North Campus Faculty Housing Phase II  
Project No. FM110407L/986315

**Addendum No. 6**

ADDENDUM NUMBER 6  
to the  
CONSTRUCTION DOCUMENTS

BUILDING 500B : SECTIONS 2

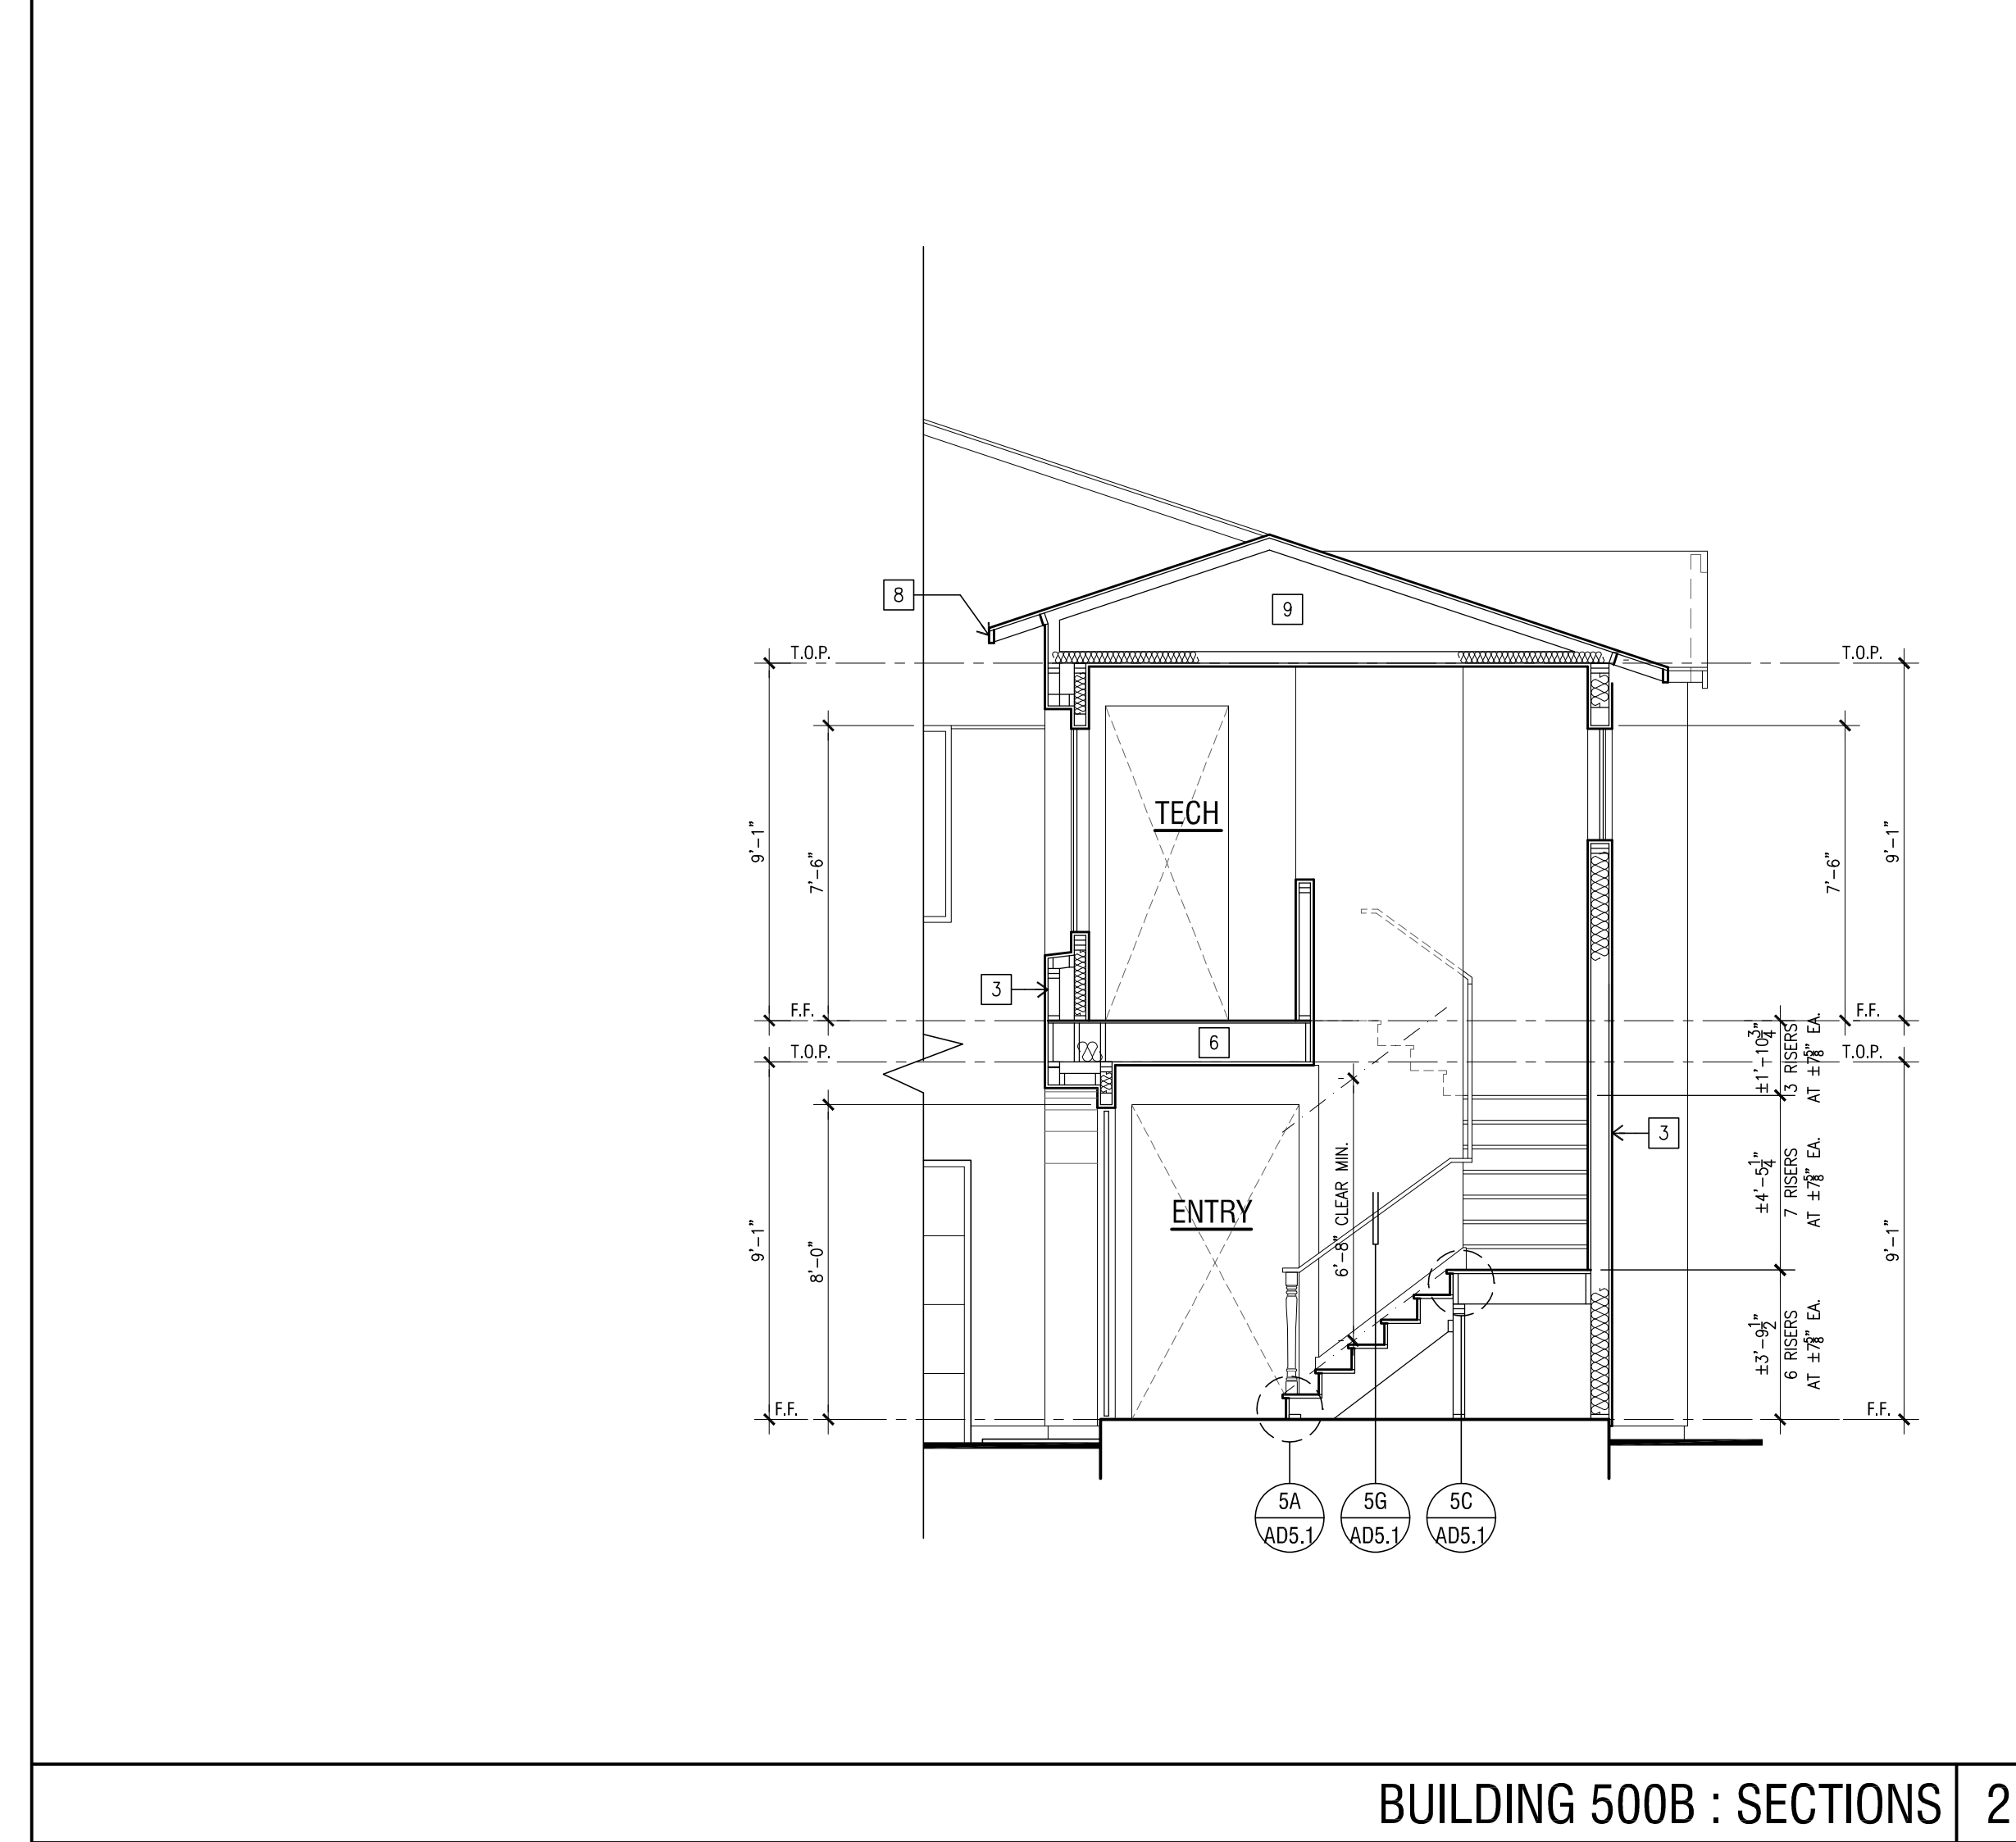
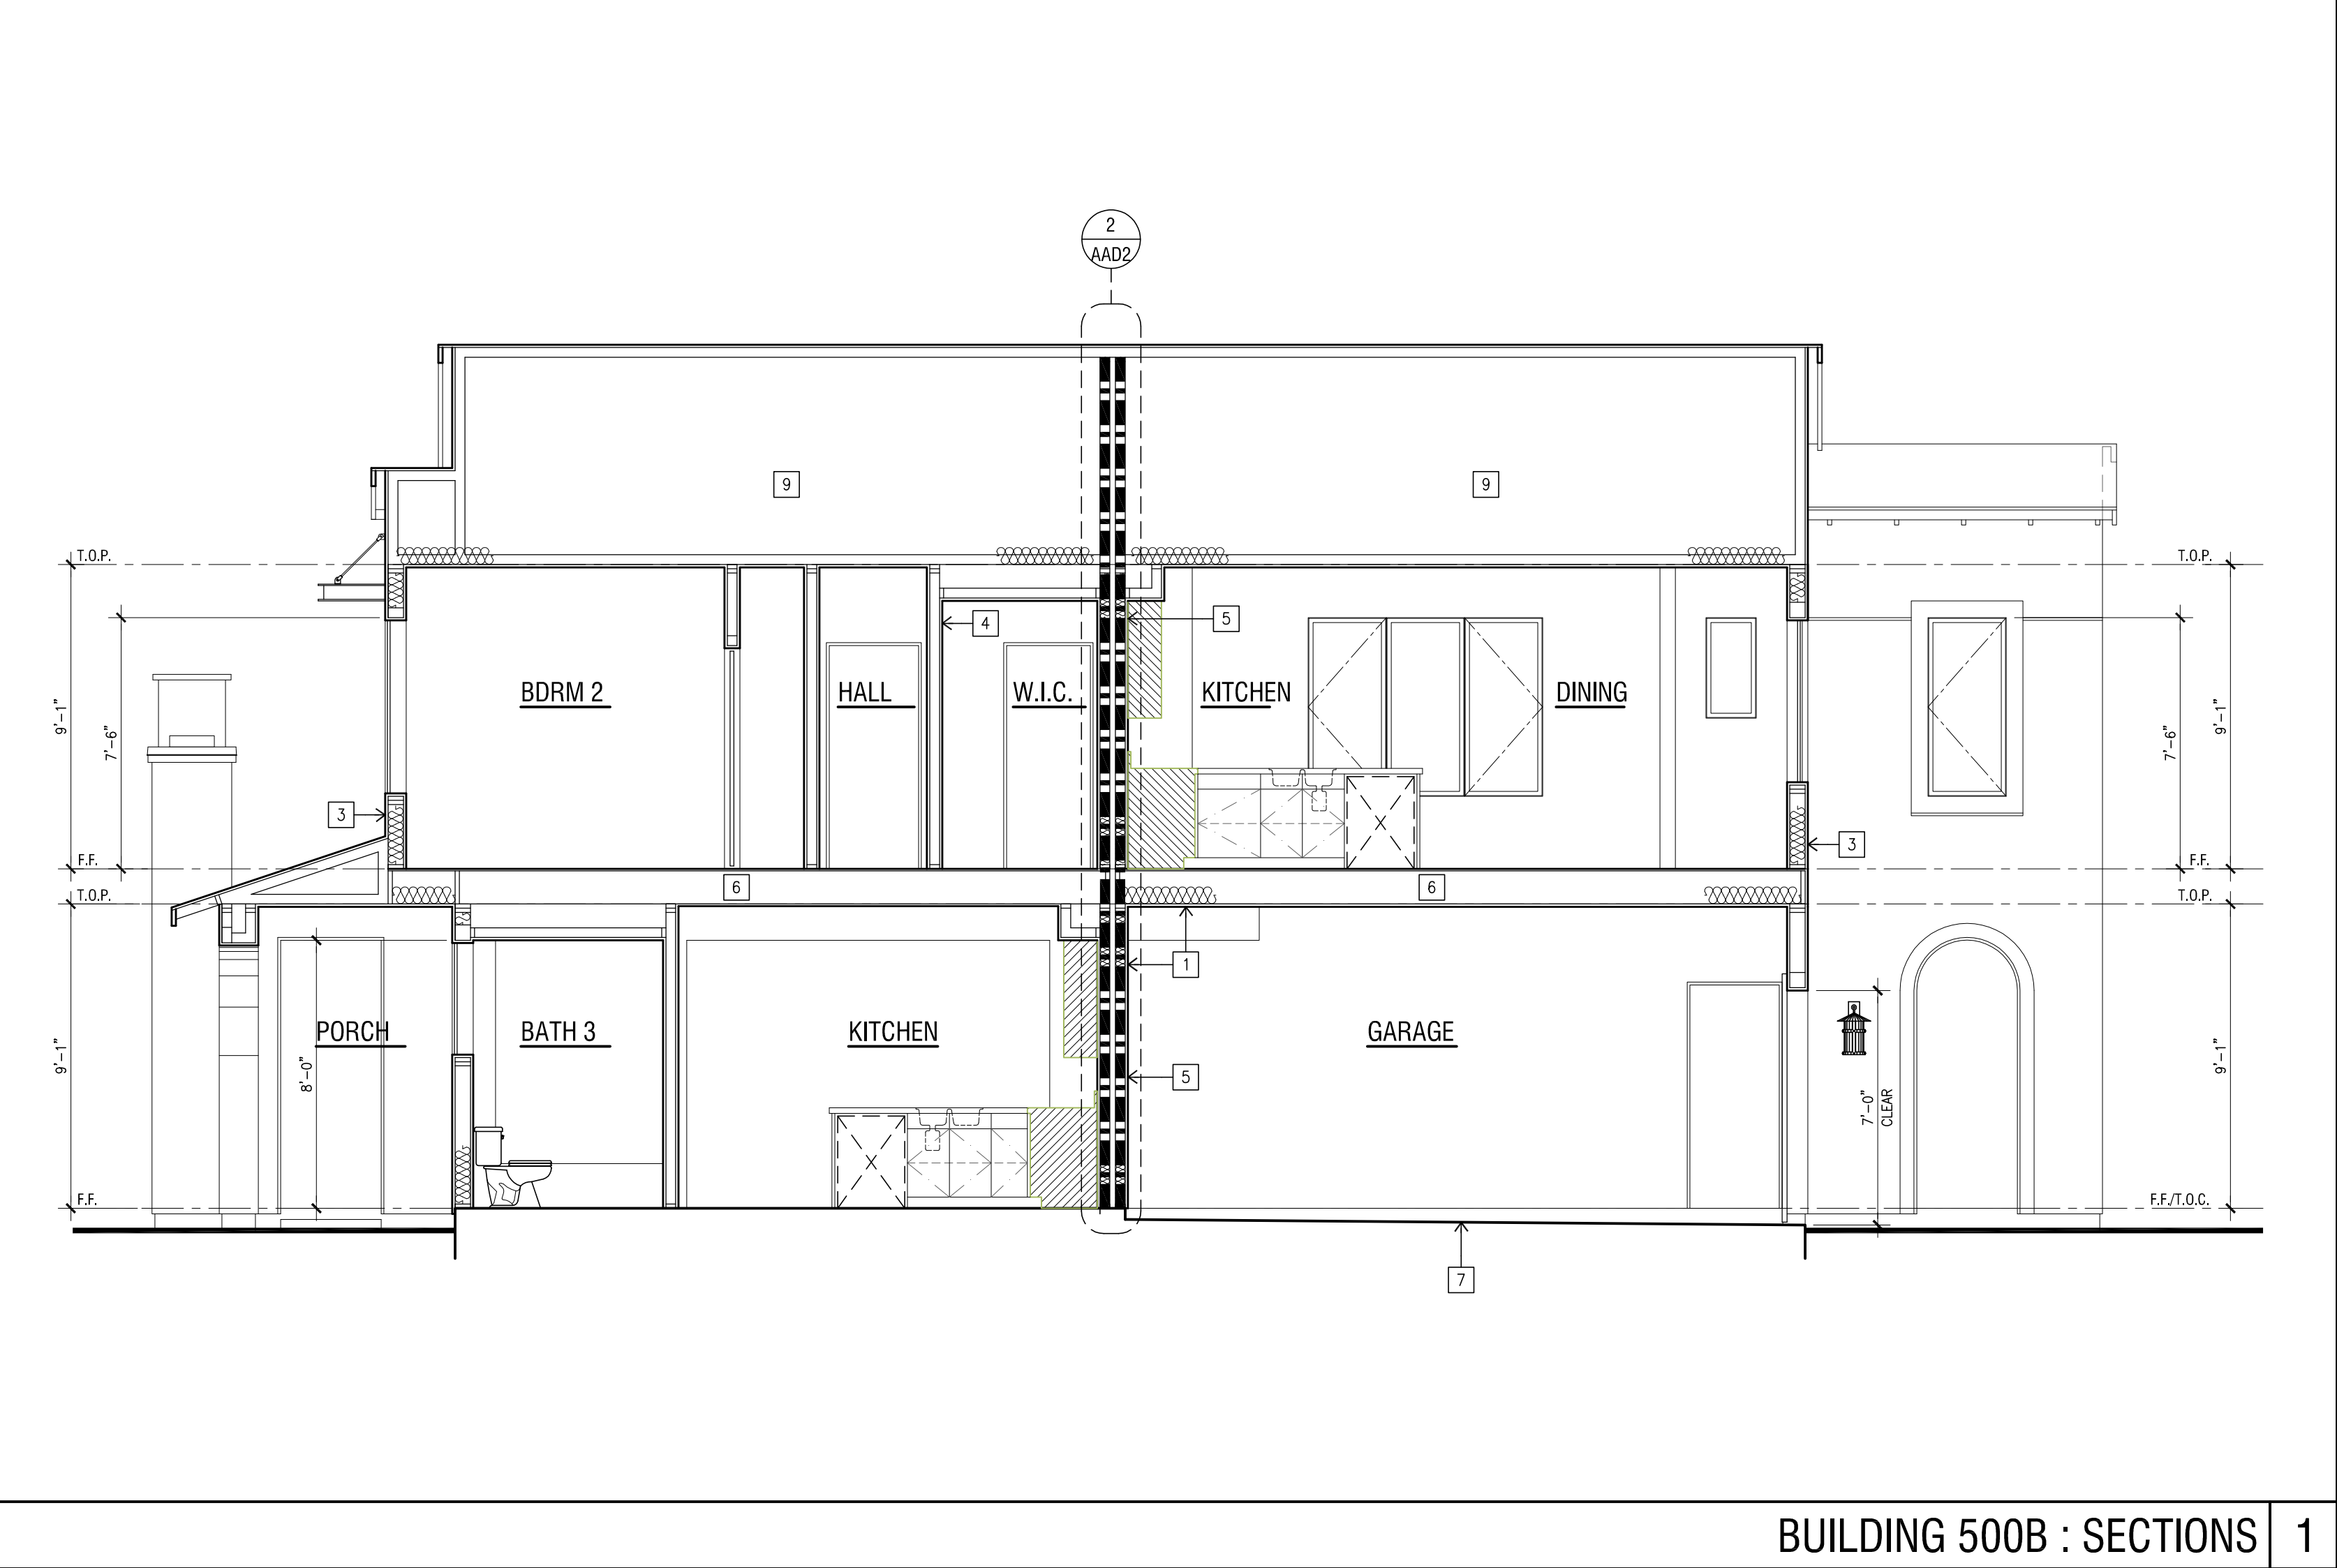
1. **Add** the attached Architect Sketches 1 of 8, dated 9/23/11.  
Sketch 1 of 8 Building 400A: Sections  
Sketch 2 of 8 Building 400B: Sections  
Sketch 3 of 8 Building 500B: Sections  
Sketch 4 of 8 Building 600A: Sections
